DR / DR-x MDI: Support for Breakout (Comments #341 and #342)

**IEEE P802.3dj Task Force Meeting
IEEE 802.3 Sept 2024 Interim**

- The following presentation addresses the following comments
 - **Comment #341** (SC 180.8.3.1) - Any DR MDI is also capable of supporting any lower lane count DR interfaces than what it is specified for as applicable, as well as combinations. Clause 180.8.3.1.1 starts off specifying 400GBASE-DR2 with twelve total positions. It could support multiple ports of 200GBASE-DR1, or could support a combination of a single 400GBASE-DR2 with two ports of 200GBASE-DR1.

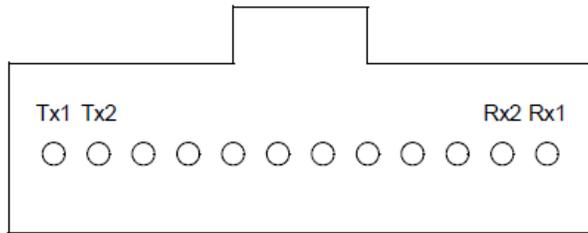
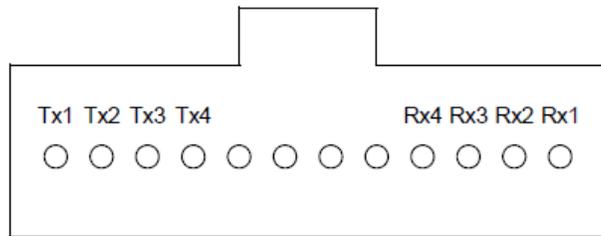
- The MDI for either single 400GBASE-DR2 or 800GBASE-DR4 and its requirements are specified in 180.8.3.3- 2 to 12 fibers
- Mapping DR2 and DR4 MDI lane assignments to the same connector
- For both assignments
 - Only single port of target PHY defined

- **Create annex for “Multi-MDI Per Connector” (w / editorial license)**
 - **Create Optical Lane Assignments to address multiple configurations for 1x 12 row fiber, based on:**
 - **200GBASE-DR1 (DR1-2)**
 - **400GBASE-DR2 (DR2-2)**
 - **800GBASE-DR4 (DR4-2)**
 - **Create Optical Lane Assignments to address multiple multiple configurations for 1x 16 row fiber, based on:**
 - **200GBASE-DR1 (DR1-2)**
 - **400GBASE-DR2 (DR2-2)**
 - **800GBASE-DR4 (DR4-2)**
 - **1.6TBASE-DR8 (DR8-2)**
- **Use suggested mapping in issenhuth_3dj_02_2409**
- **Question for the CRG – should the annex be normative or informative?**

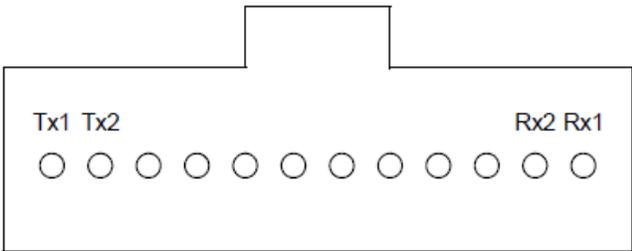
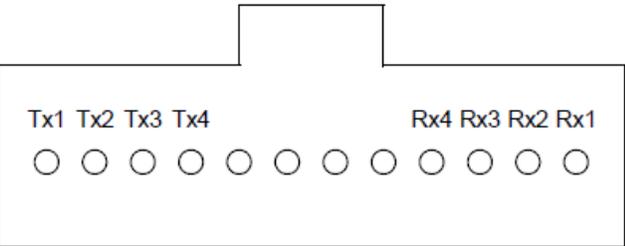
- **Comment #342** (SC 182.8.3.1~~1~~) - Any DRx-2 MDI is also capable of supporting any lower lane count DRx-2 interfaces than what it is specified for as applicable, as well as combinations. Clause 182.8.3.1.1 starts off specifying 400GBASE-DR2-2 with twelve total positions. It could support multiple ports of 200GBASE-DR1-2, or could support a combination of a single 400GBASE-DR2-2 with two ports of 200GBASE-DR1-2.

- The MDI for either single 400GBASE-DR2-2 or 800GBASE-DR4-2 and its requirements are specified in 182.8.3.3- 2 to 12 fibers
- Mapping DR2-2 and DR4-2 MDI lane assignments to the same connector
- For both assignments
 - Only single port of target PHY defined

Figure 182-9—1.6TBASE-DR8 optical lane assignments

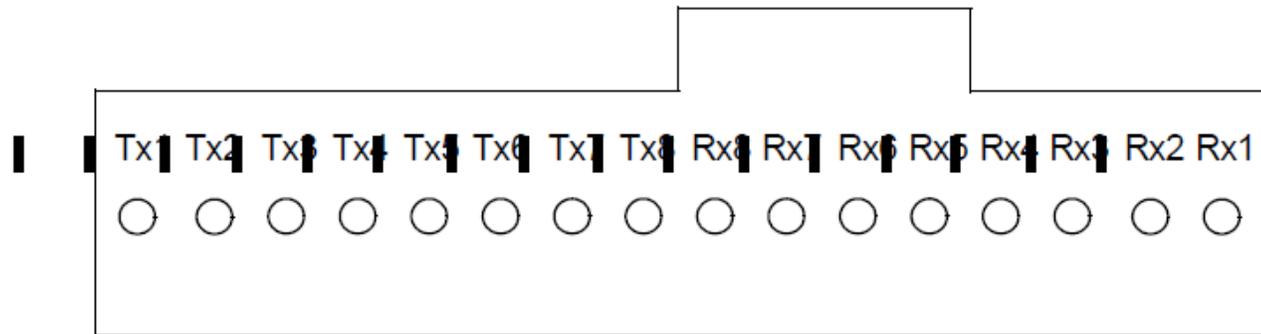
- **Only single port of target PMD implemented**
- **The MDI for a single 1.6TBASE-DR8 is specified in 182.8.3.4 for 16 fibers.**
- **Note – Caption to Fig 182-9 is incorrect – it should be 1.6TBASE-DR8-2**
